MEMORANDUM

From: Service Manager Environment **To:** Head of Environment and Planning
Our Ref: EP/DC/PP/2016/1118 **Your Ref:** SEH/P/2016/1118
Date: 5th January 2017

Location: O. S Grid Ref: 417 396 Land South of Big Green Farm, Ellesmere Lane, Penley, Wrexham.

Development: Outline application for residential development (up to 13 dwellings) and construction of new vehicular access.

Turning Areas

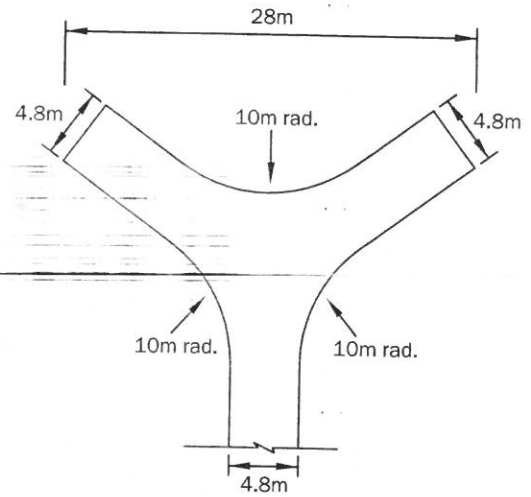
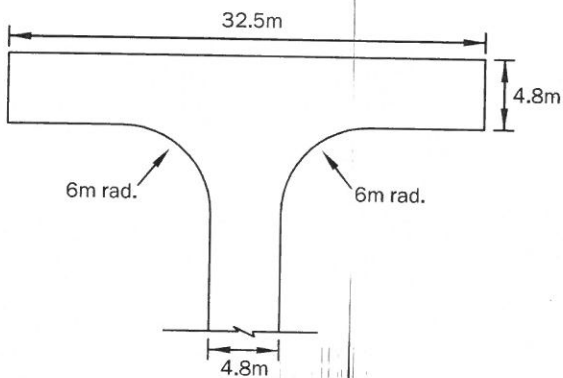
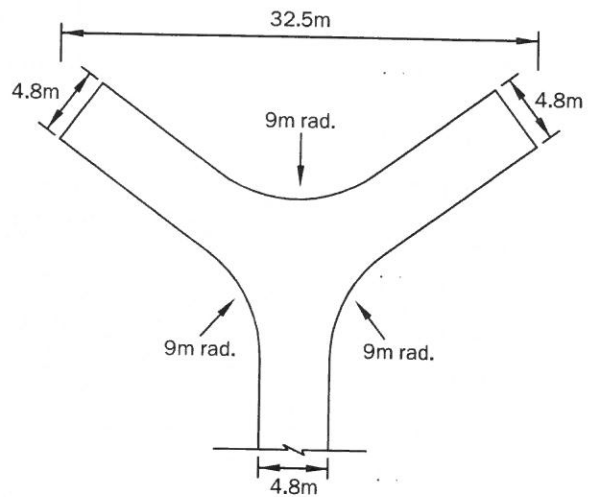
- Any proposed estate road serving up to 24 no. dwellings shall be a minimum width of 4.8m incorporating 6m kerb radii at the junction with Ellesmere Lane.
- The proposed turning head fronting plots 2– 7 will need to comply with current adoptable standards.
- The proposed turning head fronting plots 8– 11 will need to comply with current WCBC standards.
- Given the relatively remote location of the site, I would recommend maximum parking provision for each dwelling in accordance with LPGN16.
- Parking & private driveways for each dwelling shall comply with WCBC standards.
